PUYALLUP DUPLEX

ELECTRICAL SITE PLAN

DATE: 10/11/2023 SUBMITTAL: PERMIT PROJECT No. 223-328

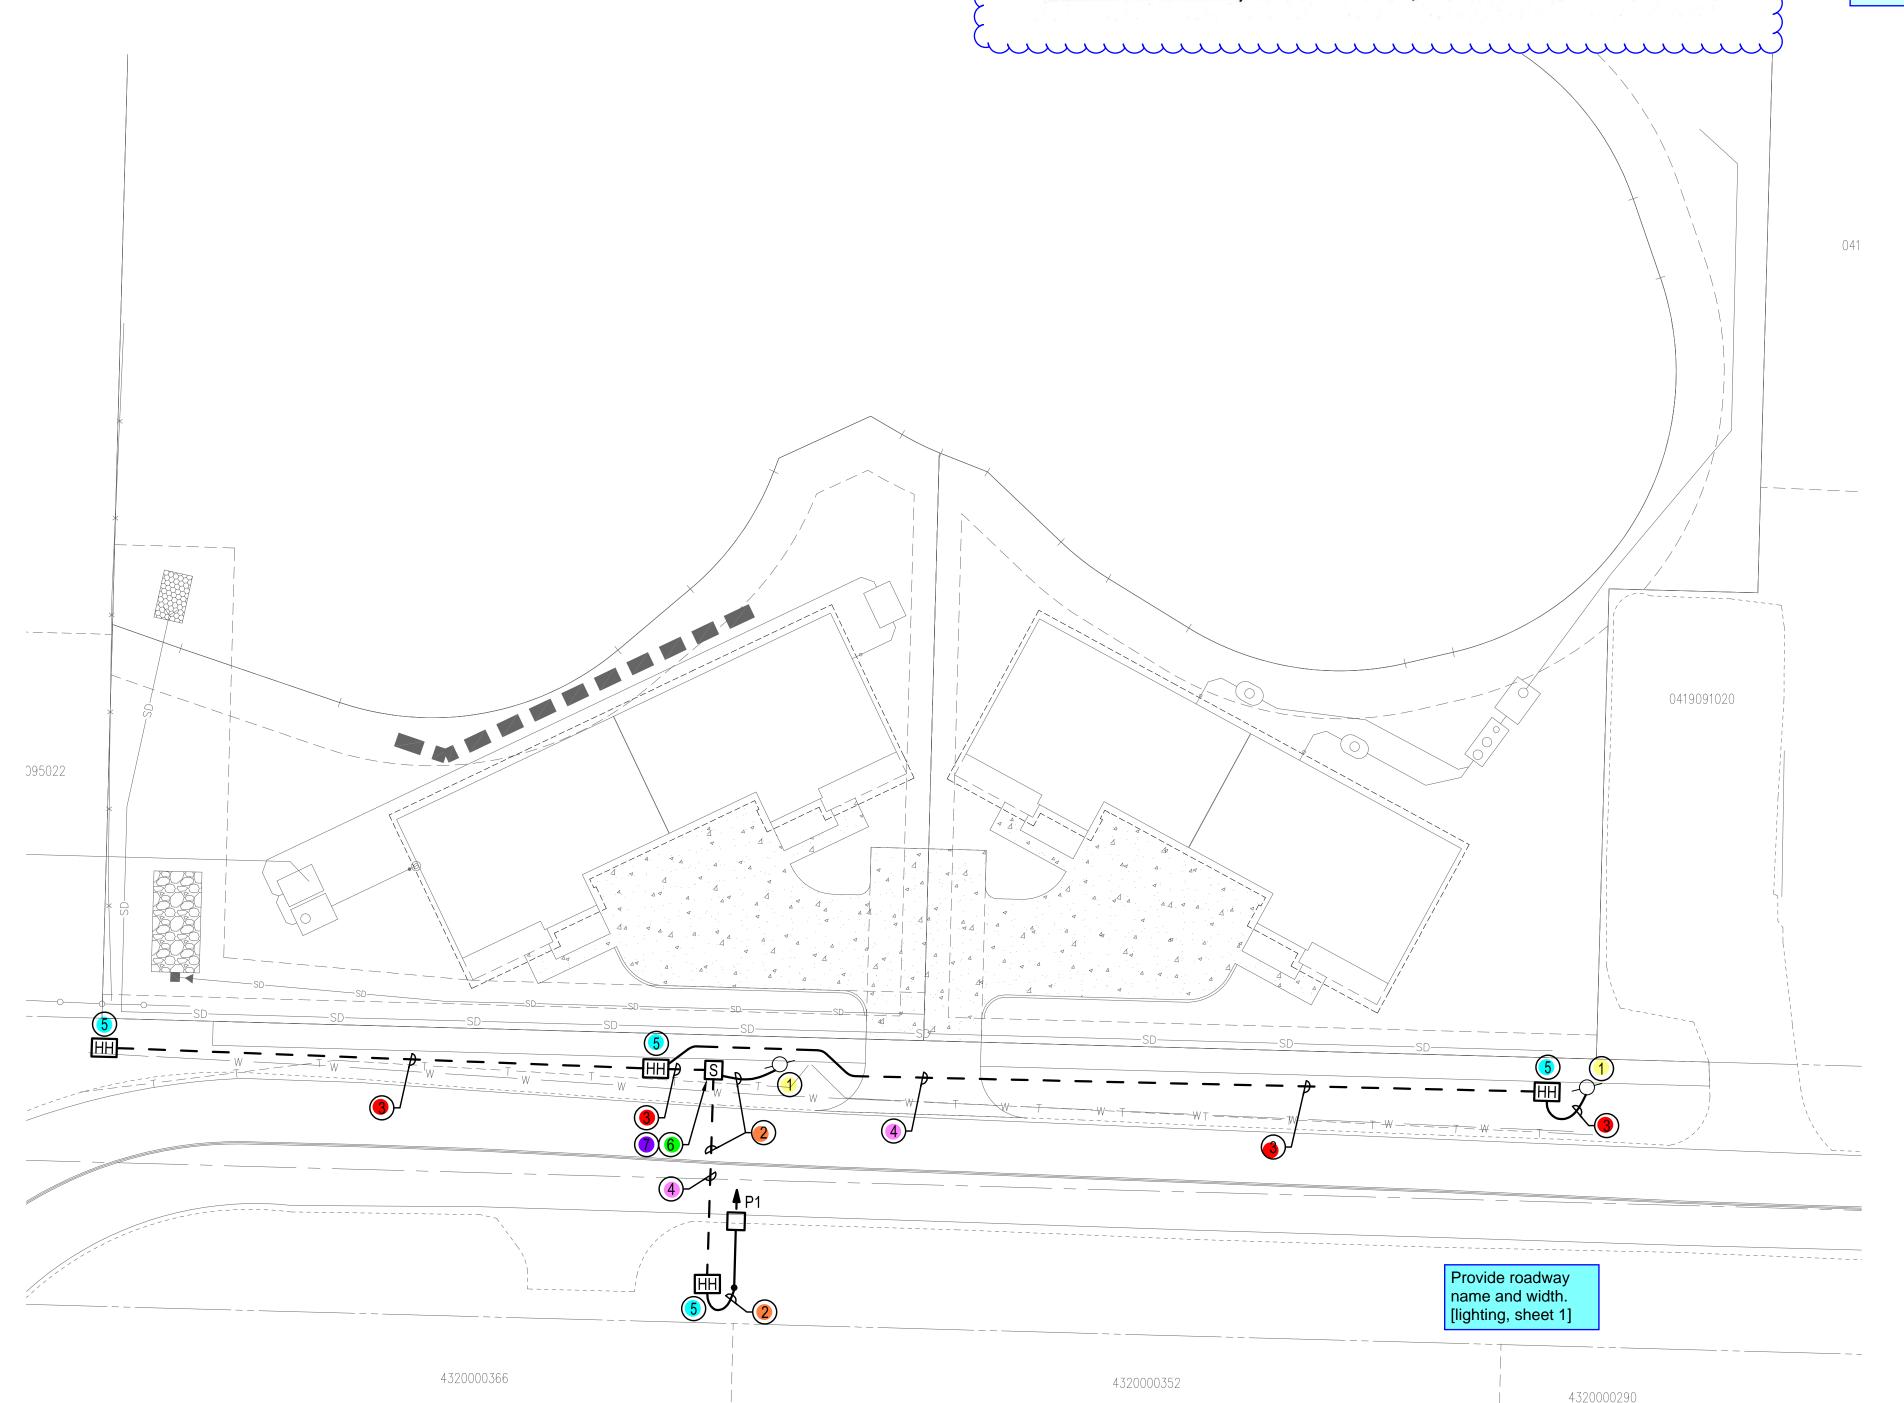
Add project name/legal description to top of the lighting plan sheet. [lighting, sheet 1]

For the next submission combine both the Civil plans and Street lighting Site Plan. [lighting, sheet 1 43rd Ave SW consists of a 60' right of way. Once this roadway is formally built out, the ROW will meet city standard 01.01.02. Show dimensions of a 5' sidewalk, and 7.5' planting strip such that the streetlight is located in the future planter strip such that the streetlight will not have to be relocated and the luminaire overhangs a minimum 3' from the future face of curb. [lighting, sheet 1]

Add a legend to this plan sheet. Be sure to include the yellow lane center striping as shown

on this sheet. [lighting, sheet 1]

Revise these general notes to state City Illumination notes [lighting, sheet E1.1]

> Include site address and parcel numbers, owner, legal description and utilities. [lighting, sheet 1]

Add to note 5 that a concrete collar is 6" thick and 6" wide completely surrounding the junction box. [lighting, sheet E1.1]
